## PLAT COMMITTEE

April 12, 2023

Case Number: 2023-PLT-015  
Property Address: 261 North Shadeland Avenue (Approximate Address)  
Location: Warren Township, Council District #19  
Petitioner: Daduwal Village Realty by Jaswinder K. Samra  
Zoning: C-4  
Request: Approval of a Subdivision Plat to be known as Daduwal Village Lots on Shadeland, dividing 2.46 acres into two lots  
Waiver Requested: None  
Current Land Use: Commercial / Undeveloped  
Staff Reviewer: Allison Richardson, Senior Planner

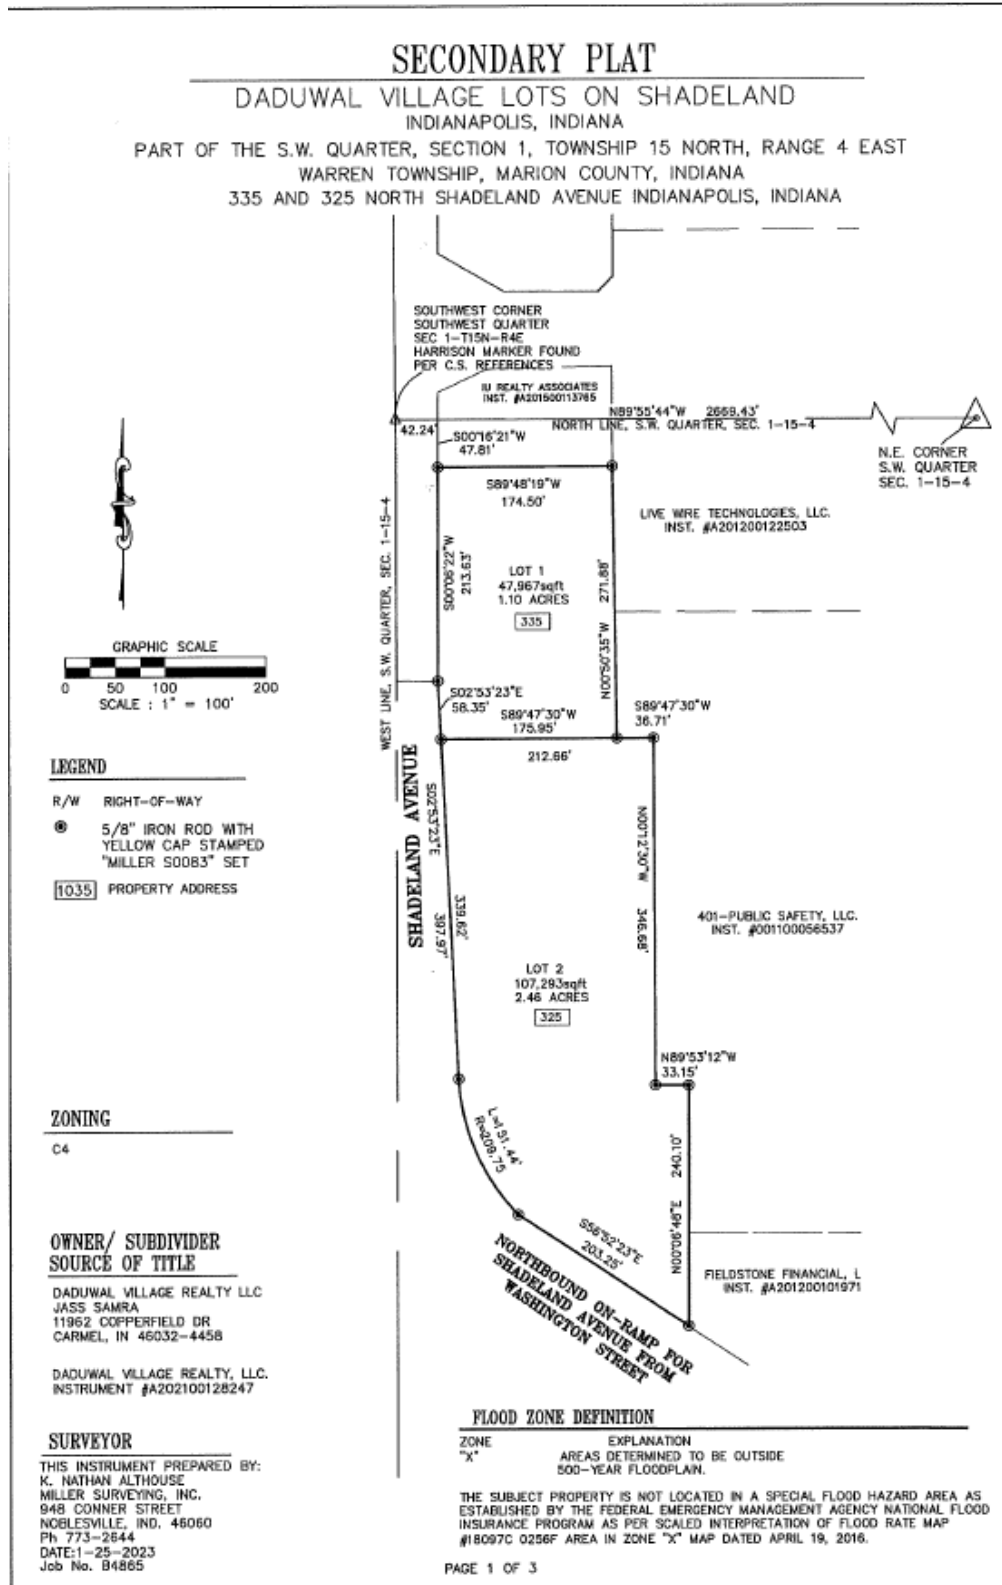
This site is zoned C-4 and developed with a commercial building, related parking, and a billboard sign. The proposed plat would subdivide the property into two lots. Lot One would contain the existing building. Lot Two would be available for a future commercial development. The proposed plat meets the standards of the C-4 zoning classification.

Sidewalks are required along Shadeland Avenue, unless prohibited by the Department of Transportation.

Staff recommends that the Plat Committee **approve** and find that the plat, file-dated March 3, 2023, complies with the standards of the Subdivision regulations, subject to the following conditions:

1. That the applicant provides a bond, as required by Section 741-210, of the Consolidated Zoning and Subdivision Ordinance; or provides documentation that sidewalks are not permitted on this portion of Shadeland Avenue.

9. That the Storm Drainage Covenant (Section 741-703, of the Consolidated Zoning and Subdivision Ordinance) be affixed to the final plat prior to recording.
10. That the plat restrictions and covenants, done in accordance with the rezoning commitments, be submitted prior to recording the final plat.
11. That all the standards related to secondary plat approval listed in Sections 741-207 and 741-208 of the Consolidated Zoning and Subdivision Ordinance be met prior to recording the final plat.
12. That an access easement on the internal access drives be shown on the final plat prior to recording.
